Access Compliance Report Public Rights-of-Way (Curb Ramps)

Main Street: LA_COLINA_DR Cross Street: RANCHWOOD_RD Location: S

ADA ID: RPRK211014133053 Ramp Type: Type 1 - Perpendicular Diagonal Initial Pass/Fail: Fail Overall Compliance: No Severity Score: 2

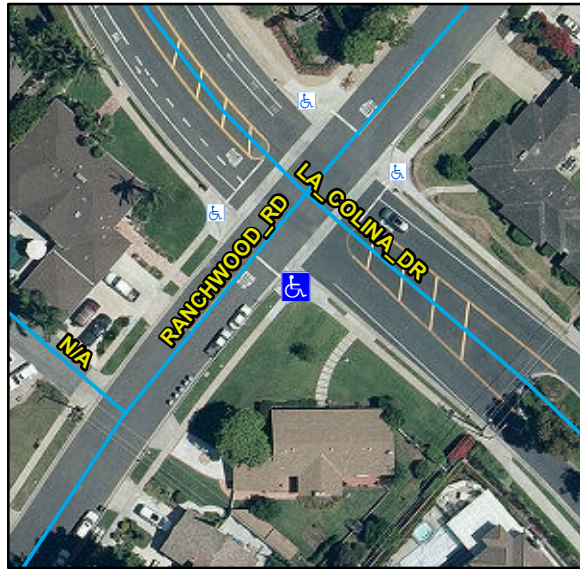
Compliance	Description	Data	Compliance	Description	Data
N/A	Ramp Length (in)	88	N/A	Flare Type LT	
Yes	Ramp Width (in)	49			N/A
Yes	Ramp Run Slope (%)	4.8	N/A	Flare Slope LT (%)	N/A
No	Ramp Cross Slope (%)	2.4	N/A	Flare Traversable LT	N/A
N/A	Landing Present	N/A	N/A	Flare Type RT	
N/A	Landing Length (in)	N/A			N/A
N/A	Landing Width (in)	N/A	N/A	Flare Slope RT (%)	N/A
N/A	Landing Run Slope (%)	N/A	N/A	Flare Traversable RT	N/A
N/A	Landing Cross Slope (%)	N/A	N/A	DWS Provided	N/A
N/A	Landing Movement Obstructed?	N/A	N/A	DWS Contrast	N/A
	Landing Movement Type	N/A	N/A	DWS Length (in)	N/A
N/A	Landing Shared	N/A	N/A	DWS Full Width	N/A
N/A	Clear Space	Yes	N/A	DWS Offset Left (in)	N/A
N/A	Clear Space To Crosswalk (in)	N/A	N/A	DWS Offset Right (in)	N/A
N/A	Marked Crosswalk 1	No	N/A	Marked Crosswalk 2	No
	Crossing 1 Direction	NE		Crossing 2 Direction	NW
	Marked Crosswalk 1 Width (in)	N/A		Marked Crosswalk 2 Width (in)	N/A

N/A	Ramp Inside Crosswalk 1	N/A	Yes	Ramp Inside Crosswalk 2	N/A
	Crossing 1 Slope (%)	0.6		Crossing 2 Slope (%)	6.6
	Crossing 1 Cross Slope (%)	4.2		Crossing 2 Cross Slope (%)	1.1
N/A	Gutter Ponding	N/A	No	Curb Slope	8.3
Yes	Gutter Lip Height (in)	0		Road Run Slope (%)	4
N/A	Gutter Run Slope (%)	N/A		Road Cross Slope (%)	5
N/A	Gutter Cross Slope (%)	N/A			
Yes	Overall Surface Condition: Acceptable		Yes	Perp Joint Present	Yes
	Cross Gutter Present?	Yes		Spandrel Present?	Yes
	Replace Cross Gutter?	No		Replace Spandrel?	No

Remove & Replace Curb Ramp With Two New Directional Ramps or Equivalent.
